# CLOONKETT WIND FARM RESPONSE TO SUBMISSIONS

Response to Submissions received by ACP,  
ACP Ref. PAX03.323783

Document No:  
P26014-FT-XX-XX-RP-PL-0001

Receptor Figure

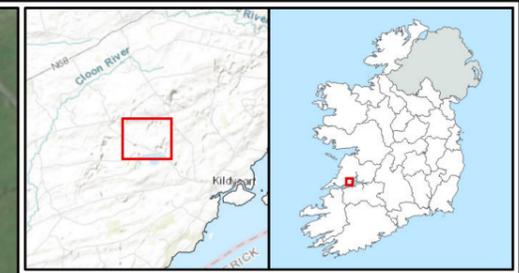
<p>Item 15.7: Concerns are raised around 3 no. residential properties which are claimed to be left out or unaccounted for in the mapping and assessments within the submitted EIAR. One further property is alleged to be left out, and is claimed to be a derelict property within 600m of a turbine.</p>	<p>Frank Ranalow claims that his property is 450m from T10. There are a cluster of buildings located 600m-750m south of T10. It is noted that the closest Eircode data within this cluster is to the south, approximately 708m from T10. This was identified in the EIAR assessments as Property ID 138. The planning status of the cluster of buildings is unknown with no planning records of a dwelling house at this location.</p> <p>It is noted that one submission Noel King alleges that T14 is located a distance of 588m to the curtilage of his dwelling. Whilst the Observers property ownership may extend closer to turbine T14, a GIS based assessment was applied in the EIAR and it can be substantiated that the curtilage of the residential receptor is 622m from T 14 which is in excess of 4 times tip height set back. This was identified in the EIAR assessments as Property ID 233.</p> <p>It is noted that one submission Rita O’Dea alleges that her dwelling is within 600m of a proposed turbine location. This property was identified in the submitted EIAR assessments as Property ID 227. Based on a GIS assessment of distance to nearest turbines, Property ID 227 is 619m from T8 as the nearest turbine to dwelling. This is in excess of the 600m setback distance.</p> <p>In relation to the John Hehir submission, there would appear to be a cluster of farm structures at this location which is c. 375m from T14. This is not identified as a residential receptor and no EirCode associated with them, as there is no habitable dwelling at this location. There is an outline of a potential ruinous structure proximate to the farm buildings.</p> <p>Please refer to accompanying Appendix 2, which contains mapping with the properties in question highlighted, and their distance from the nearest turbine.</p>
